Model: CDP-C235
CDP-C335**No. 390****Subject:** Motor Drive Circuit Modification**Date:** April 26, 1994**Symptom:**
(62)

Model: CDP-C235, CDP-C335, CDP-C435, CDP-C535

SUPPLEMENT-1

SUPPLEMENT-2

Subject: Part Number Missing - Reference No. -, Main Chassis

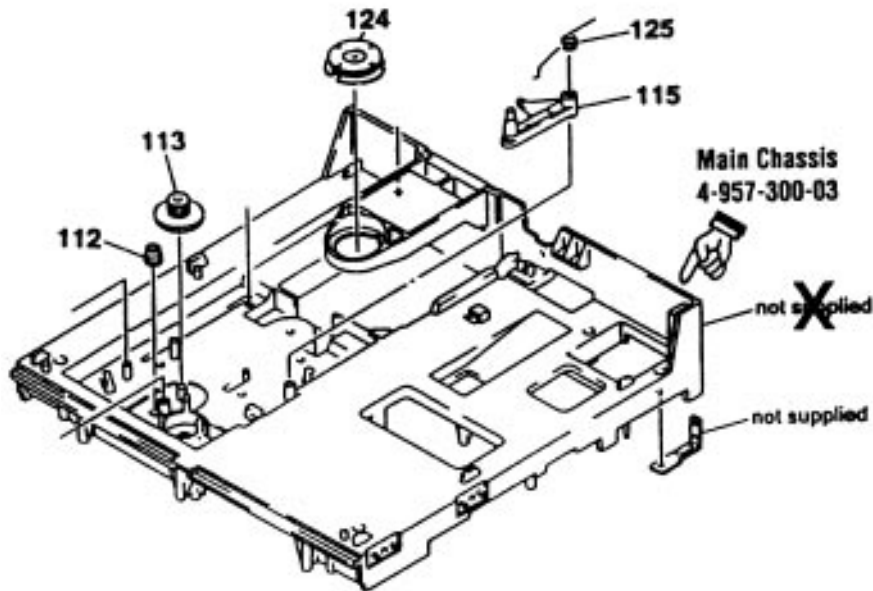
The part number for Ref # -, Main Chassis, which is shown on page 23 of the Service Manual, is not listed in the parts list.

Please add the following part number to the Service Manual.

REF	DESCRIPTION	PART NUMBER
-	MAIN CHASSIS	4-957-300-03

Subject: Preventing Shipping Damage When Repaired Units Are Returned To Customers. **Date:** August 31, 1993

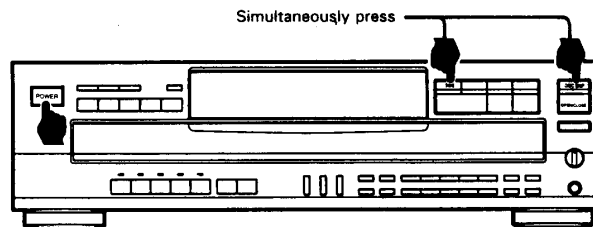
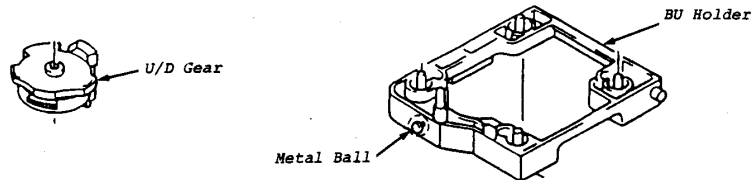
Shipping damage may occur if the BU holder is not set to the "up" position before packing the unit. Typically, the metal ball attached to the BU holder becomes dislodged from the U/D gear if the unit is dropped during shipping.

Solution: Prevent shipping damage by making sure the BU holder is set to the "up" position before packing the unit. To do this quickly...

- Simultaneously press the reverse AMS button and Disc Skip button.
- Turn on the power while keeping the buttons pressed.
- When the words "NO DISC" appears on the display, turn off the power.
- The unit can now be shipped safely.

CORRECTION

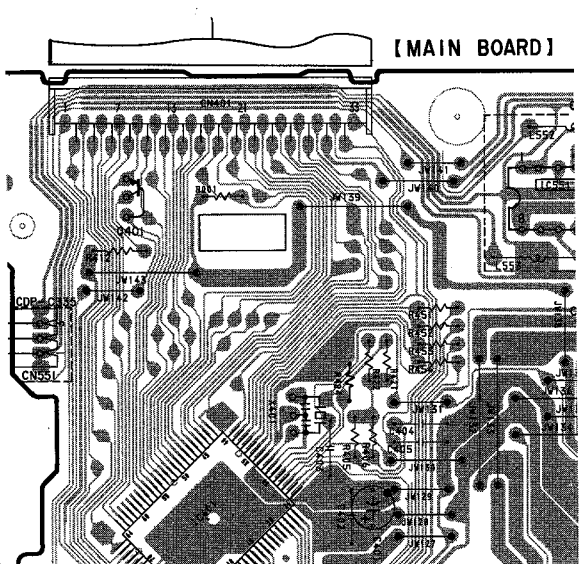
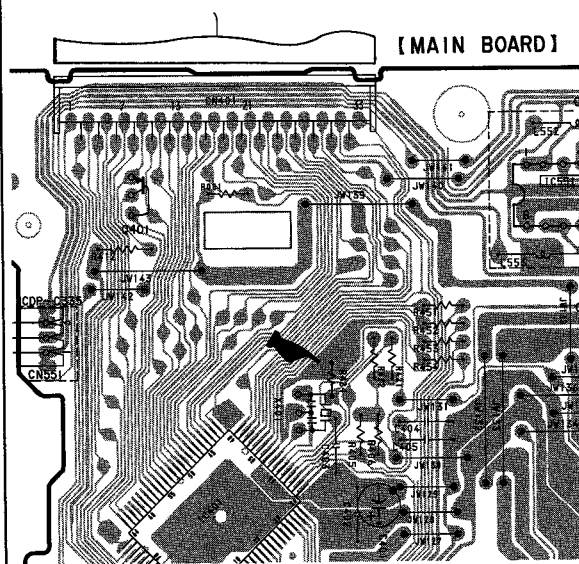
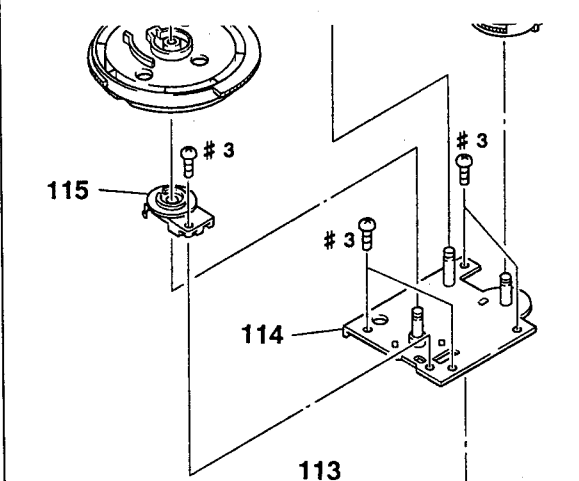
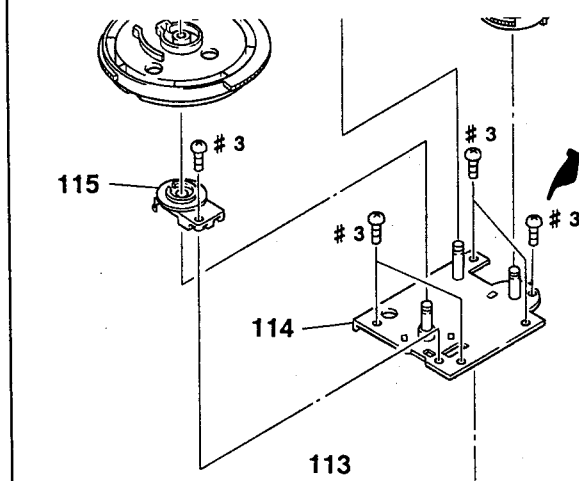
Page	Incorrect	Correct
13		
23		
	121 4-958-593-01 SPRING (BU), COMPRESSION	121 <u>4-948-503-01</u> SPRING (BU), COMPRESSION

Please correct your Service Manual.
6-3. CHASSIS ASSEMBLY (Page 23)

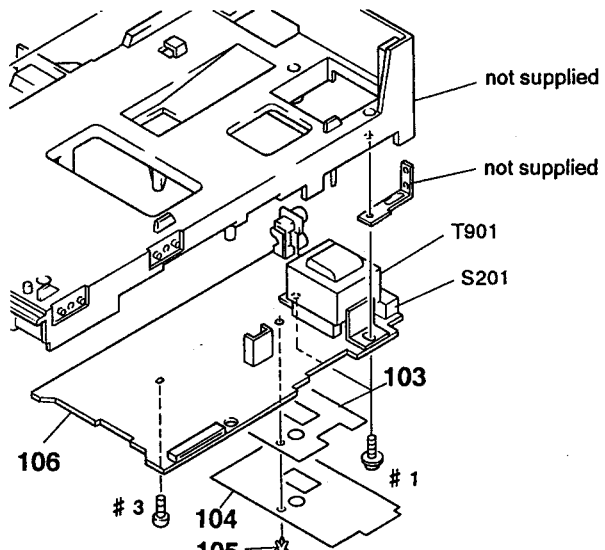
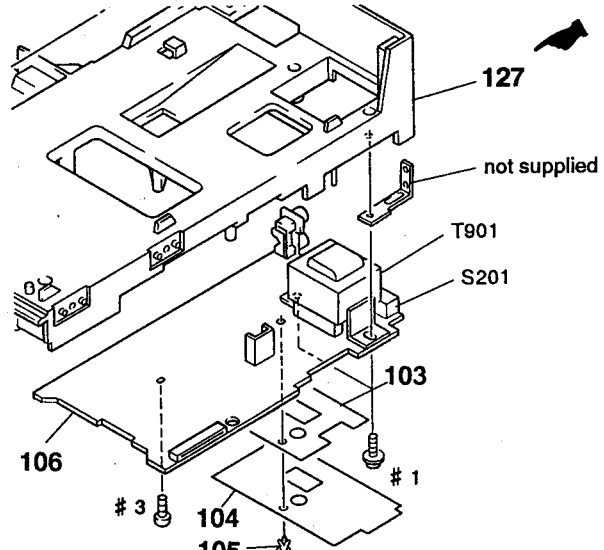
The position of the rotary encoder must be adjusted when attaching the gear (MAIN). If its position is not adjusted properly, problem may occur afterwards during operation.

<u>Ref. No.</u>	<u>Part No.</u>	<u>Description</u>	<u>Remark</u>	<u>Ref. No.</u>	<u>Part No.</u>	<u>Description</u>	<u>Remark</u>
				* 127	4-957-300-03	CHASSIS

Model: CDP-C235, CDP-C335, CDP-C435, CDP-C535**No. 490****Subject:** Substitution for KSS-390A**Date:** June 14, 1996**Symptom:****(**)**

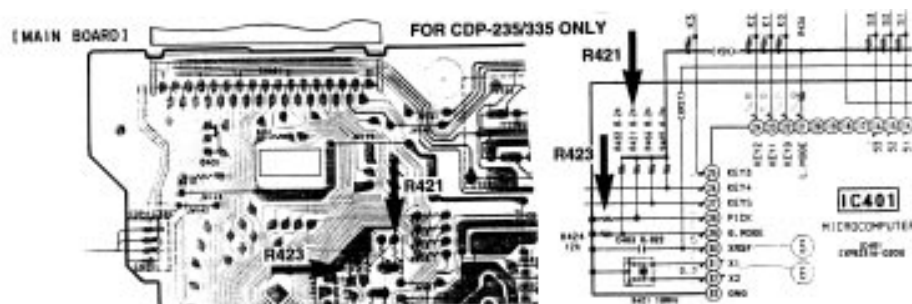
The Optical Block KSS-390A is no longer available and KSS-240A is supplied as the substitution. As the two parts have some electrical and mechanical differences, please perform the following changes according to the model being serviced.

1. Check the value of R421. If it is 8.2K Ω or less, leave it in circuit. Otherwise, remove it and replace it with a jumper wire.
2. Confirm the existence of R423. If it is mounted, remove it. This is needed to keep pin 28 of IC401 High when operating CD function.
3. Replace the flat wire which connects the BD Board and Optical Block with the new type listed below.

Just replace the flat cable with the new type. No circuit modifications needed.

Description	Part Number	Note
Flat Cable	1-575-001-11	This cable must be used with KSS-240A
